HISTORIC AND DESIGN REVIEW COMMISSION

September 20, 2017

HDRC CASE NO: 2017-475
ADDRESS: 1010 BURNET ST
LEGAL DESCRIPTION: NCB 1660 BLK H LOT E 25 FT OF 3 & W 12.5 FT OF 4
ZONING: R-6, H
CITY COUNCIL DIST.: 2
DISTRICT: Dignowity Hill Historic District
APPLICANT: Markus Lopez
OWNER: Ruben and Rebecca Lopez
TYPE OF WORK: Column Replacement, Addition, Roof Modification, Window Installation and Replacement, Rear Porch Reconstruction, Paint, Tax Certification

1010 BURNET ST
PROPOSED ROOF
PLAN

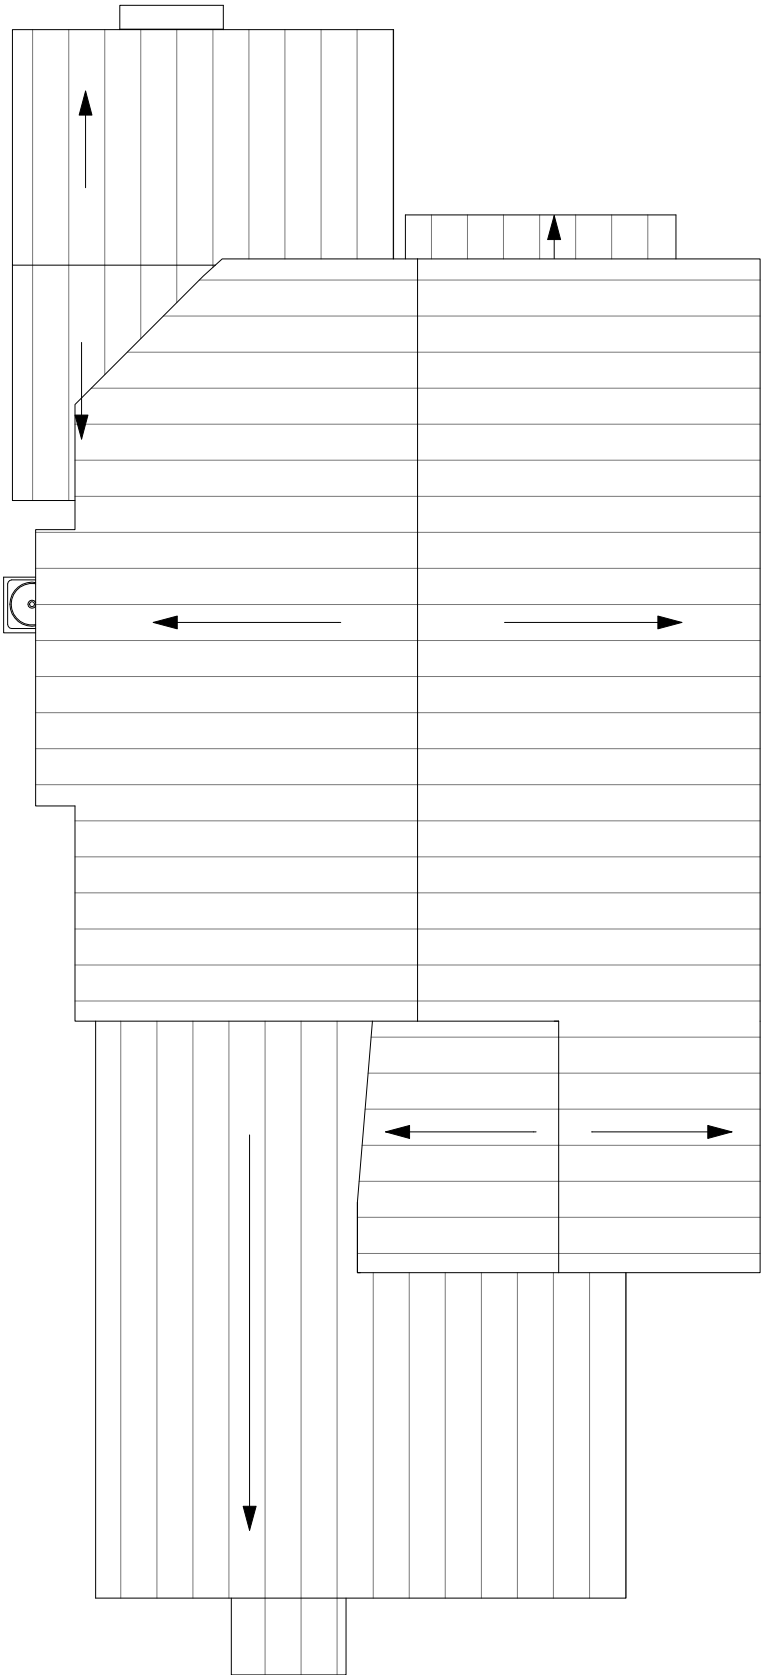
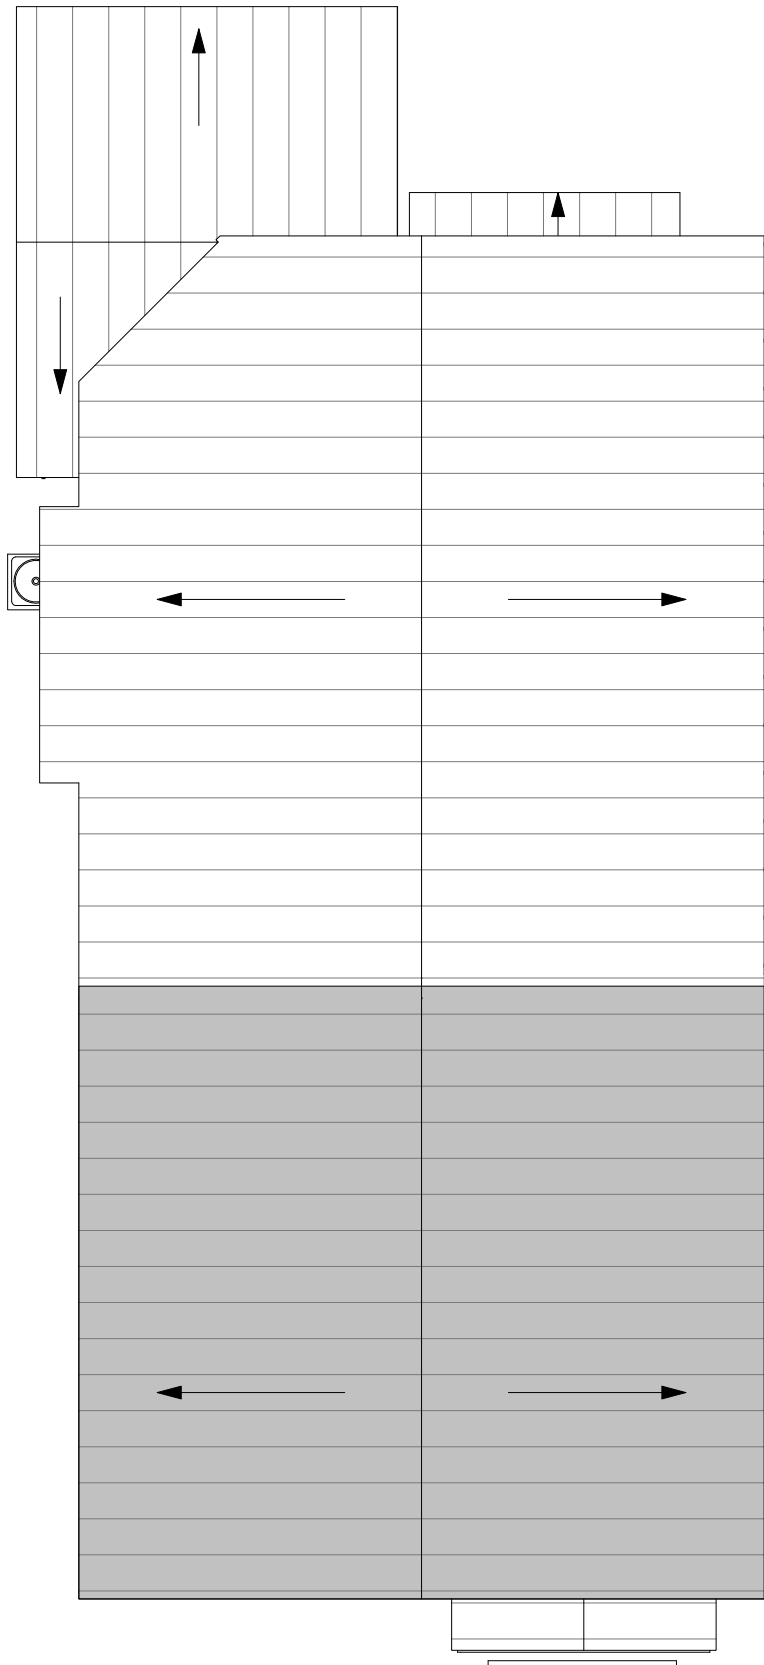
- e. ROOF FORM – The applicant has proposed to demolish the secondary gable roof and flat roof over the rear of the structure and to expand the existing primary gable roof over the existing rear and the proposed addition. The Guidelines for Additions 3.1.A.iii requires the utilization of similar roof pitch, form, overhang, and orientation as the historic structure for additions. Staff finds the demolition of the secondary roofs and the expansion of the primary roof in respect to the proposed addition appropriate.

- 1. The new roof form must be offset and subordinate to the historic structure’s primary gable roof.
- 2. That the proposed addition be more narrow than the existing house and be inset from the existing exterior wall planes.

PROPOSED FLOOR PLAN

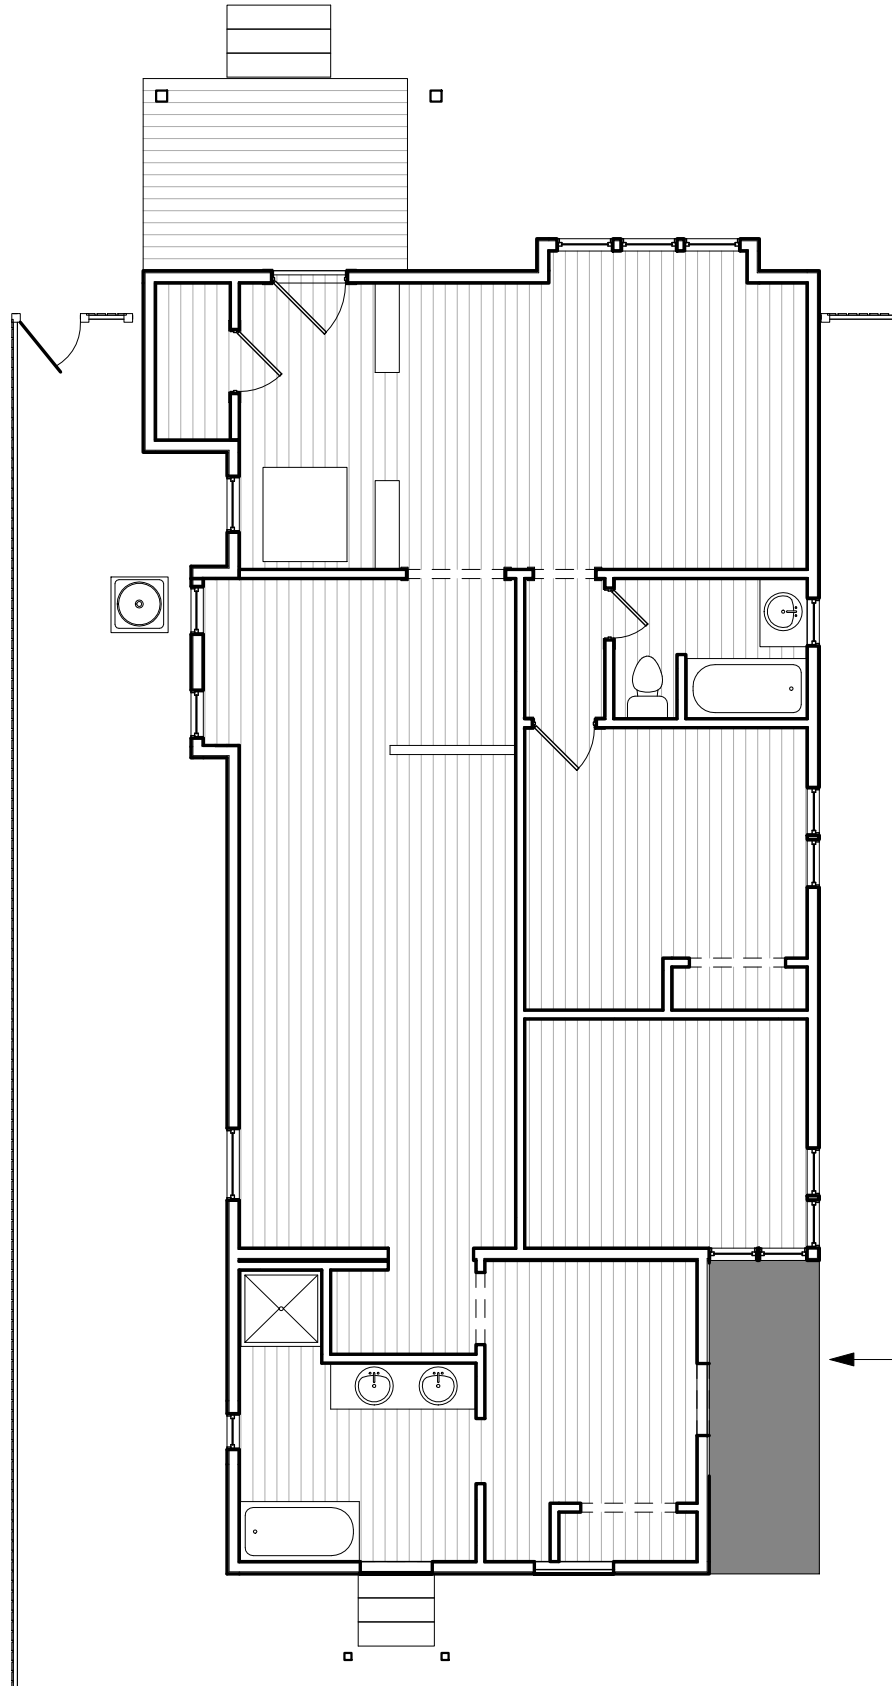
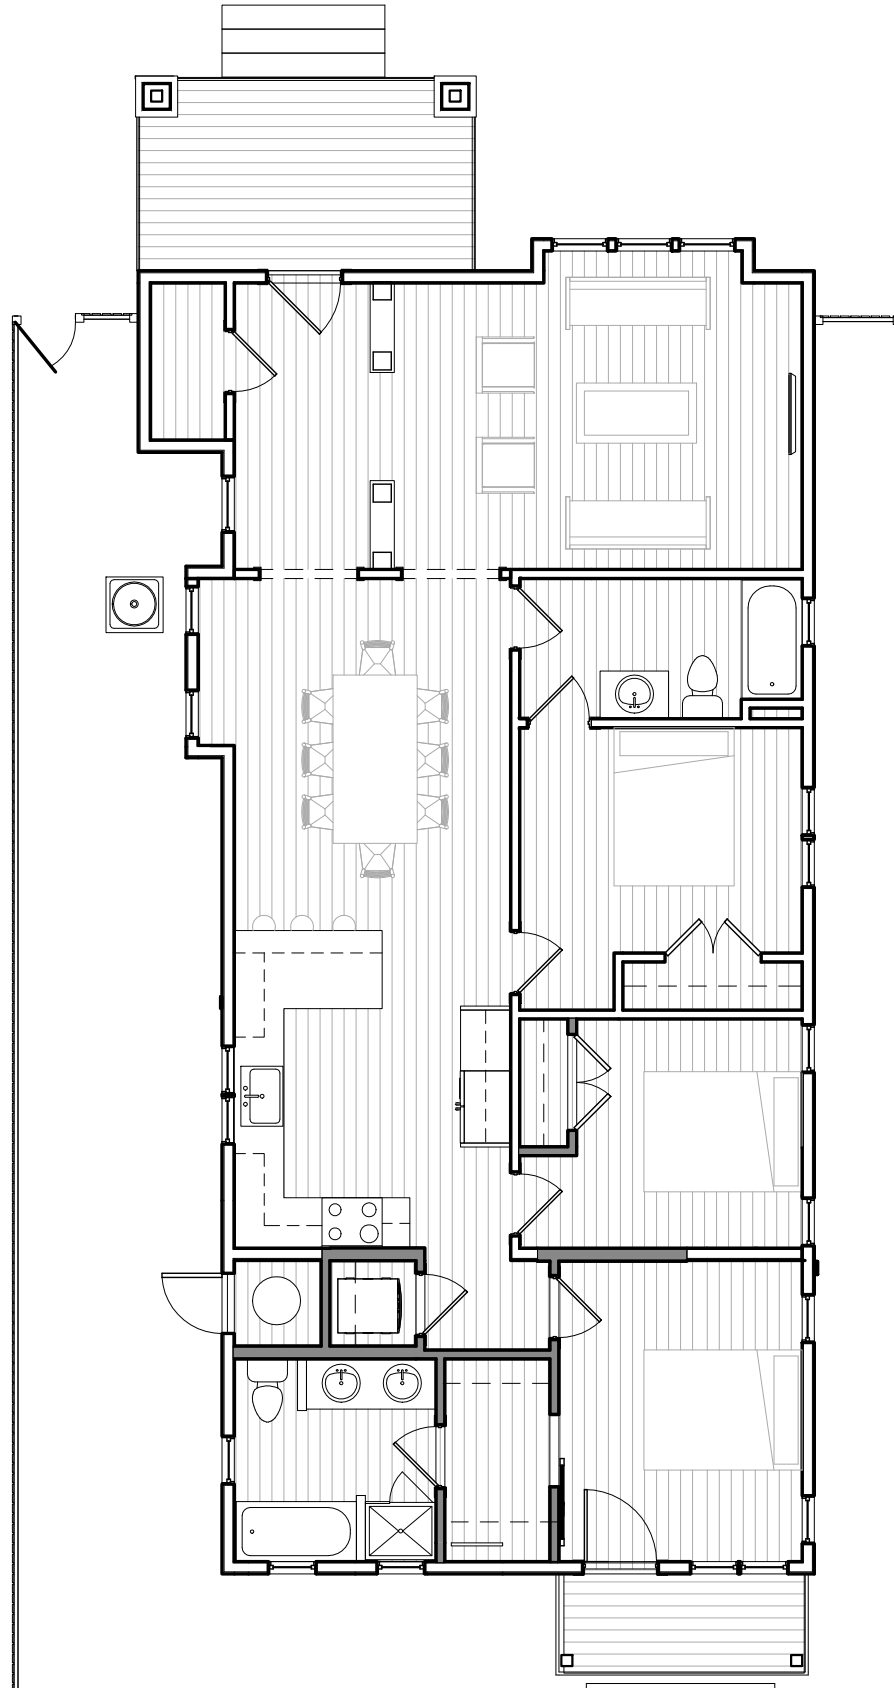
- c. ADDITION – The applicant has proposed to construct a rear-side addition to feature approximately 60 square feet. The Guidelines for Additions 3.1.A.i requires residential addition to be sited at the side or rear whenever possible. Guide lines 3.1.B.iv requires additions to respond to the size of the lot and to not double the existing building footprint. This is consistent with the Guidelines.

- d. TRANSITION BETWEEN OLD AND NEW – According to the Guidelines, new additions should utilize a setback or recessed area and a small change in detailing at the seam of the historic structure and new addition to provide a clear visual distinction between old and new building forms. The currently-proposed footprint of the addition with uniform roof plane is not consistent with this requirement. Staff finds that the addition should utilize a similar roof form that is subordinate or set below the existing rear gable, and a more narrow width which would allow the addition to be inset from the existing exterior wall planes.
